F.E. Weymouth Water Treatment Plant Improvements Program

Final Environmental Impact Report

Metropolitan Report No. 1471

E-3

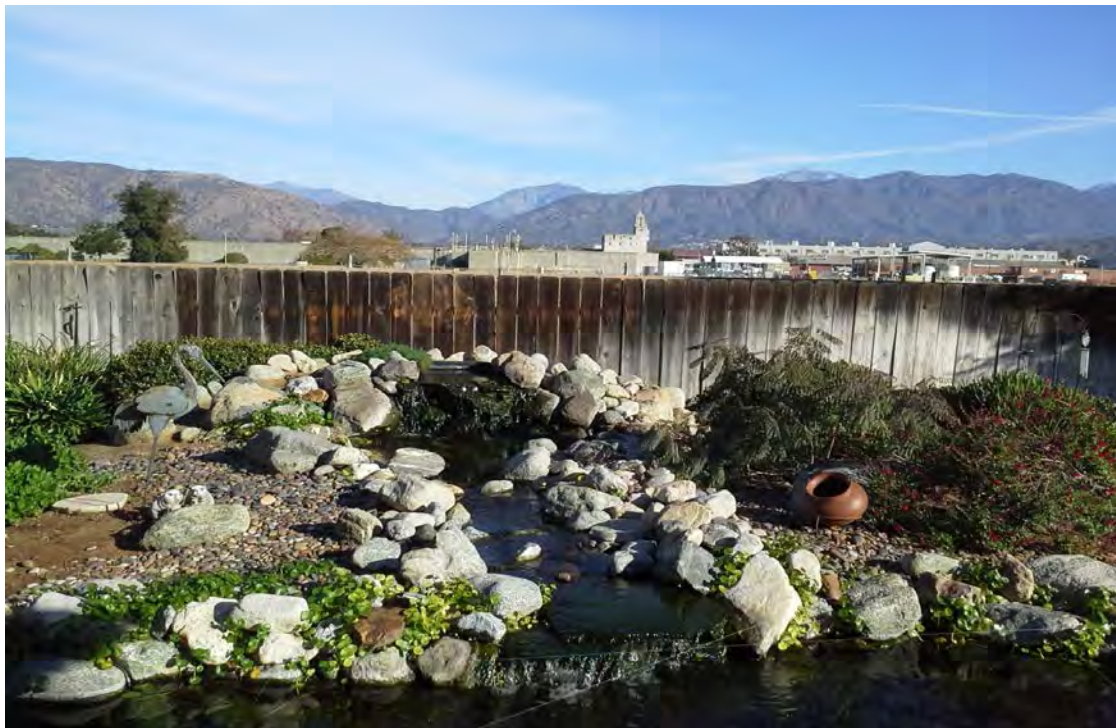
In regards to the proposed solar installation on the MWD property located at the northeastern site of the proposed facility (off of Wheeler Avenue) the properties to the north are developed with two-story single family homes. A six foot tall block wall is located along the rear of these properties. In addition "Metropolitan has planted 10 to 12 foot tall conifers spaced approximately 20 feet on center". "As the trees mature, they would act as landscape screening to soften the appearance of the water treatment facility." This appears to be an attempt by MWD to mitigate the visual impact to these properties. Properties to the east of Wheeler Avenue (a four lane roadway) are developed with single-family residences, a park and other non-residential uses which do not face onto the treatment plant.

In contrast, the homes on the north side of Highland Drive directly abut the “site” where solar panels are proposed. The homes were designed with their living rooms facing north with a view of the vacant lot, the mountains, the water treatment plant and in some cases, single-family residences fronting on Sedalia.

Recently a 7’-0” high block wall was completed along the south property line of the “site”. The photos below are taken from my back yard (1281 Highland Drive). As you can see, the 7’-0” wall does not effectively screen any of the plant facilities. Because of the grade change between the properties, the new wall is only a couple of inches higher than the existing 6’-0” high fence.

In response to public comments received, Metropolitan commissioned a consultant to prepare visual simulations of the solar generation facilities. A consultant, VisionScape Imagery, prepared four visual simulations of the proposed solar generation facilities. The visual simulations were prepared based on the following assumptions: (1) the solar panel array system would be approximately seven feet high (panel plus the foundation); (2) a setback from the plant property boundary of approximately 20 feet; (3) approximately seven-foot tall chain link fence with vegetation at the northeast site; and (4) approximately seven-foot tall solid block wall at the southwest site.

The visual simulations can be found within Appendix A of this Final EIR. Figure 1 shows the location of the visual simulations. Two views were selected to mirror views KVP 5 and KVP 6 in the Aesthetics Section of the Draft EIR. All four views were taken from public vantage points (i.e., along public roads). The simulations indicate the panels located at the northeastern site would be screened by the vegetated fence, as seen on Figures 2 and 3. The only area from which the panels would be visible from a public vantage point is through the entrance gate that does not have vegetation growing on it. As seen on Figures 4 and 5, the simulations indicate the solar panels within the southwestern facility would not be visible over the block wall.

Metropolitan also modified the project design to reduce potential solar panel visibility by selecting an approximately seven-foot tall solar panel array system and incorporating setbacks around the perimeter of the solar facilities. The visual simulation used a setback of twenty feet; however, the proposed setbacks for the southwestern solar facility from residences along Highland Drive will be greater, ranging from thirty to forty feet. The westernmost arrays will have a setback of forty feet from residences along Highland Drive due to an existing stormwater catch basin, while the easternmost arrays will have a setback of thirty feet from homes along Highland Drive. As a result, the panels would not pose a
